SERVICE BULLETIN

* Supersedes Service Bulletin SB900-092R1, dated 30 June 2003. Revised to change nut part number and closing force range. Aircraft that are in compliance with SB900-092R1 meet the intent of this revision.

MAIN ROTOR BLADE RETENTION BOLT INSPECTION

Figure 1. Blade Retention Bolt

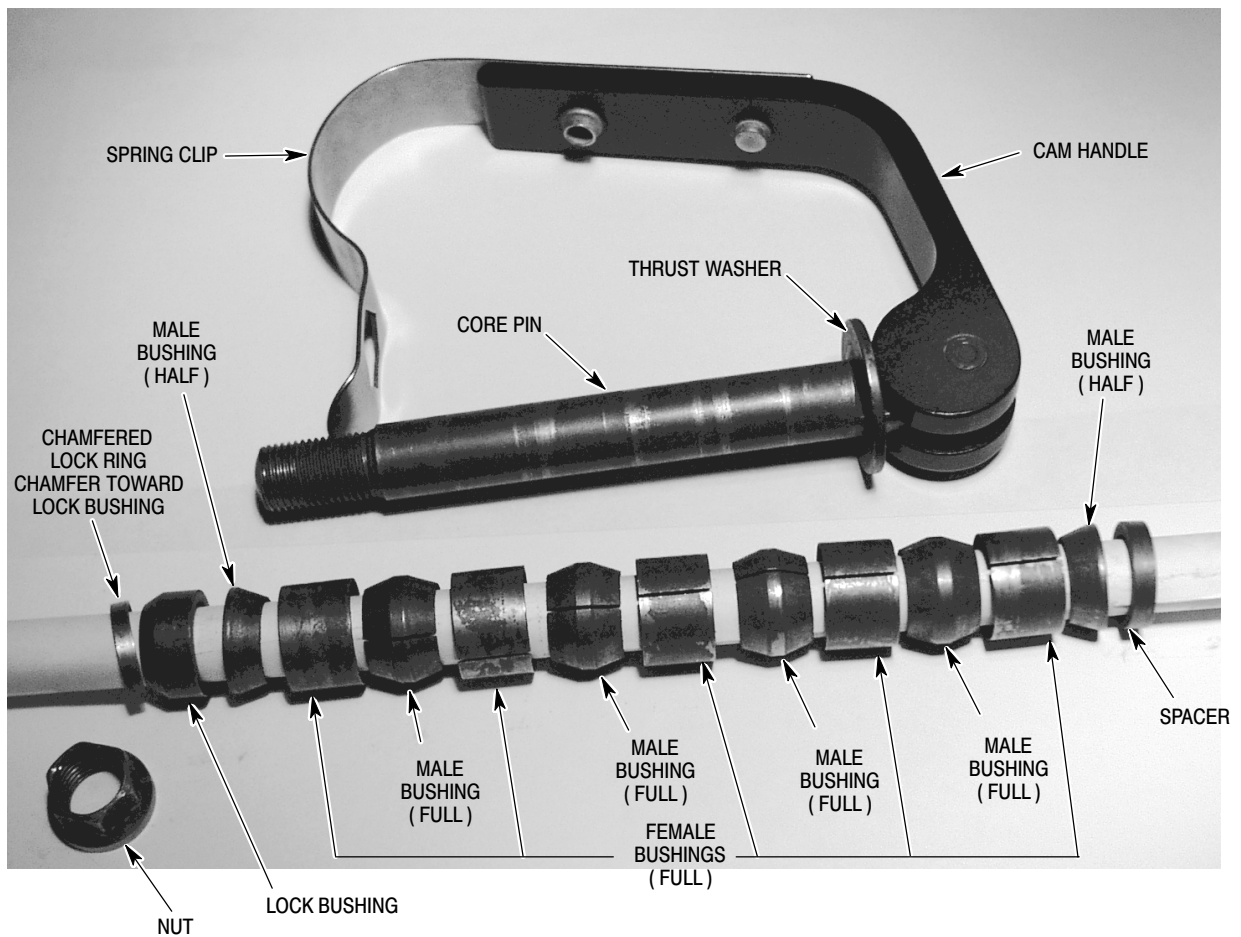
- (1). Check that position of installed blade retention bolts have not shifted upward.
- (2). Visually inspect installed blade retention bolts for gap between thrust washer and retainer.
- (3). If any blade retention bolt has shifted position upward or there is no gap between thrust washer and retainer, accomplish Part 2 of this Bulletin prior to flight.
